Rezoning Transportation Analysis

Petition Number: 2018-165

General Location Identifier: 16719305

Date	Description
01-18-19	First Review
02-18-19	Second Review

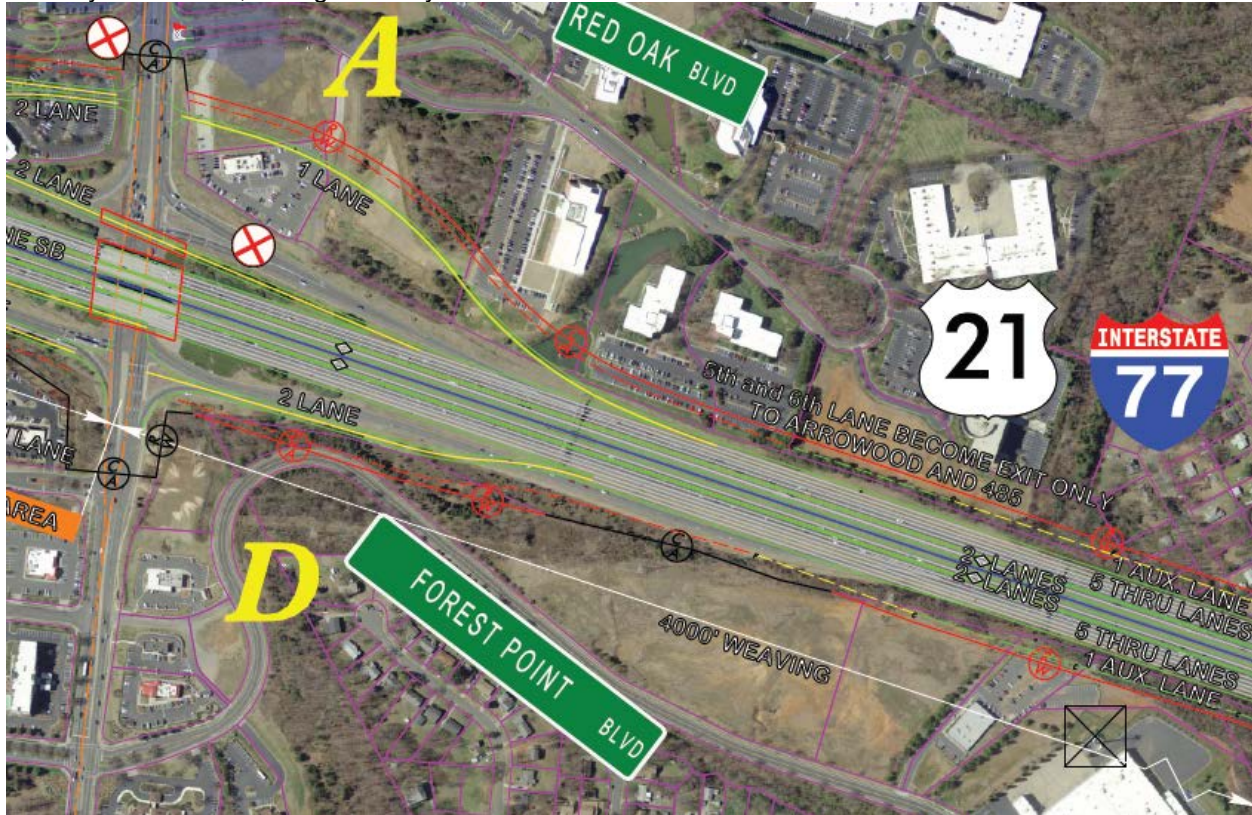
The site is located on a major collector. The site plan commits to streetscape improvements along the site frontage in the form of 8-foot planting strip and 6-foot sidewalk. CDOT continues to request pedestrian improvements at the intersection of Forest Point Boulevard and Arrowood Road to support the increase in pedestrian traffic the site will generate.

2. The petitioner shall revise the site plan and conditional note to commit to pedestrian improvements for the intersection of Forest Point Boulevard and West Arrowood Road. This improvement is required to mitigate the additional pedestrian traffic that will be generated by the development.
3. ~~I-77 is identified to be widened in the future. A preliminary study was completed showing the possible lane configuration. The petitioner should revise the site plan and conditional notes to show the future right-of-way as this may affect the site layout. The petitioner should commit to dedicating the right-of-way. In addition, the right of way should be labeled and dimensioned from the road centerline.~~
